**FOUNDATION INVESTIGATION REPORT  
FOR  
BLACKSTONE/CRAVE LAKE ROAD UNDERPASS  
W.P. 408-97-01  
G.W.P. 290-97-00, SITE 44-383  
HIGHWAY 69, DISTRICT 52  
HUNTSVILLE, ONTARIO**

**FOUNDATION DESIGN REPORT  
FOR  
BLACKSTONE/CRANE LAKE ROAD UNDERPASS  
W.P. 408-97-01  
G.W.P. 290-97-00, SITE 44-383  
HIGHWAY 69, DISTRICT 52  
HUNTSVILLE, ONTARIO**

Re: Final Foundation Investigation Reports  
Hwy 69 - Four Laning From Tower Rd. Northerly 26.5 km to North of Hwy 141  
Blackstone/Crane Lake Underpass, W.P. 408-97-01, Site 44-383  
CNR Overhead, W.P. 405/406-97-01, Site 44-381 N&S  
Healey Lake Road Underpass, W.P. 400-97-01, Site 44-377  
Tower Road Underpass, W.P. 399-97-00, Site 44-321  
Airport Road Underpass, W.P. 407-97-01, Site 44-382  
G.W.P. 290-97-00, Hwy 69, District 52, Huntsville

BOREHOLE LOCATION PLAN  
AND SOIL PROFILES

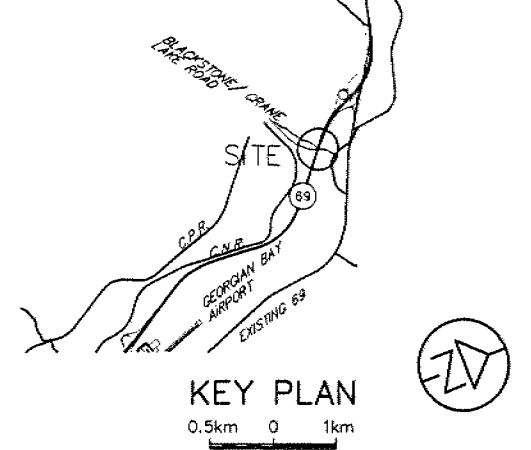
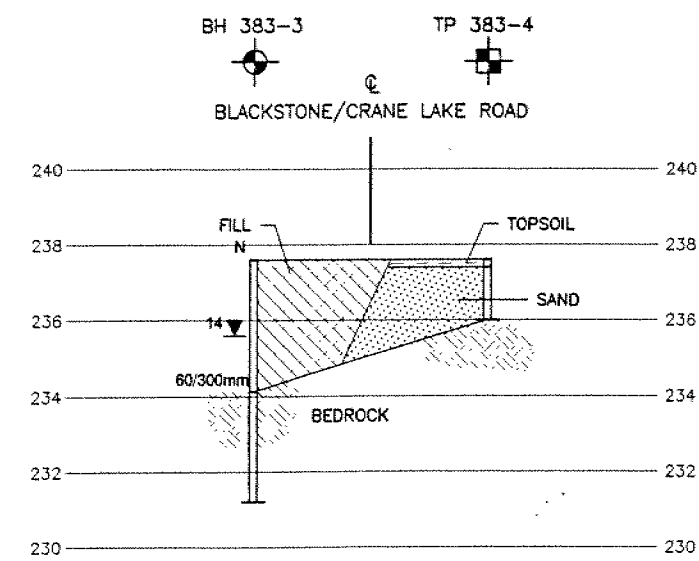
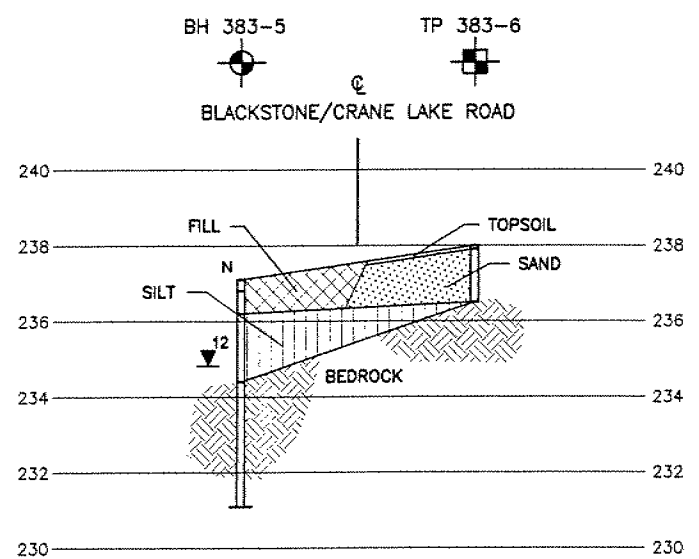
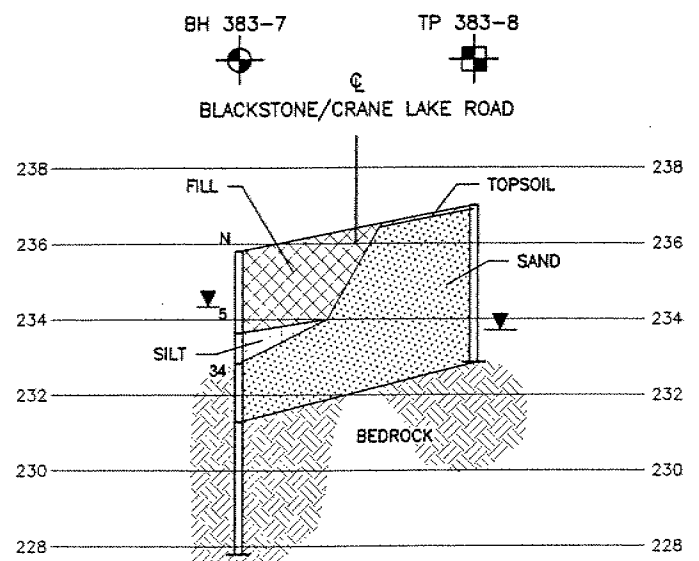
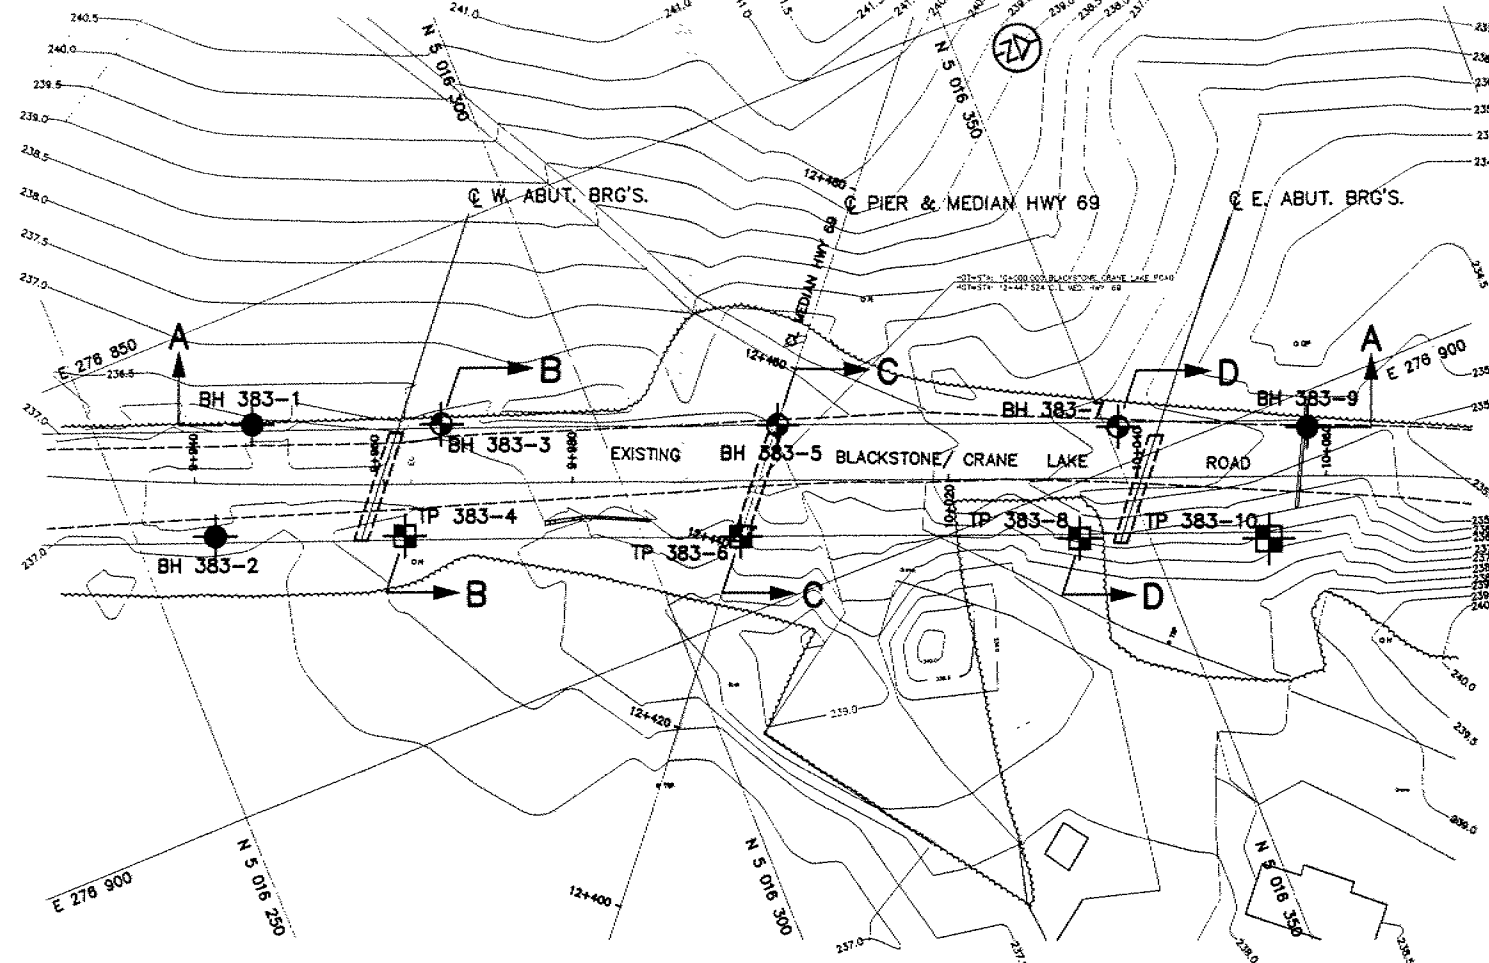
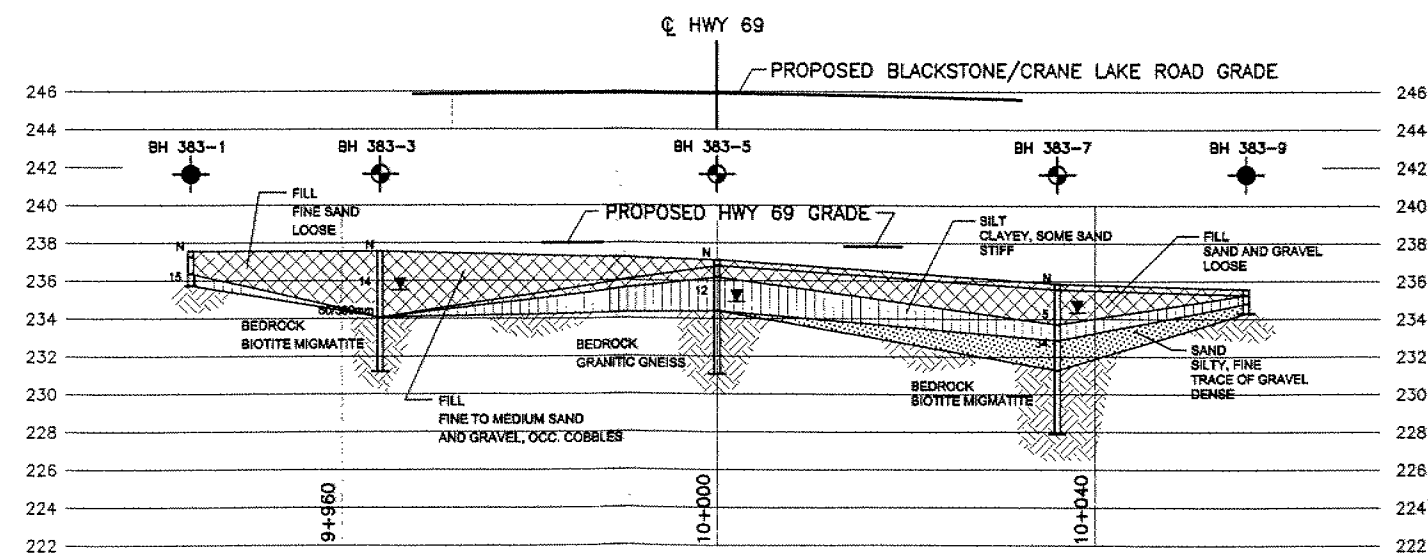
2. Recommendation should be given for the side slopes of the approach fills.
3. The Key Plan, northing and easting and the stations shown on the plan are very small. After the drawings are reproduced to include in the contract package, they would not be legible.

4. The cross sections are very small (some of them are thumb size) and should be enlarged. These cross sections will be included in the contract package. When they are reproduced for the contract package, they would not be legible. The plan is produced in 1:500 scale. The cross sections are normally 100 percent larger than the plans to show the details. But in the report the cross sections are 50 percent reduced. Ideally the cross sections should be in true scale, i.e. same horizontal and vertical scales. If the true scale is not feasible, then the ratio of horizontal and vertical scales should be 2. The ratio of the horizontal and vertical scale in the foundation reports are 5. The cross sections, therefore, are very distorted. All the cross sections do not have to fit on one drawing. Cross sections can be produced on more than one drawings. A sample copy of the standard drawing can be obtained from the Pavements and Foundations office.

5. A bar scale, similar to the one provided on the plan should also be provided on the cross sections
6. The Pavements and Foundations Section has assigned Geocres Numbers for these projects. The Consultant should provide the Geocres numbers on the Final Reports. The Geocres number shall be shown on the lower left corner of the Title Page of the Foundation reports.
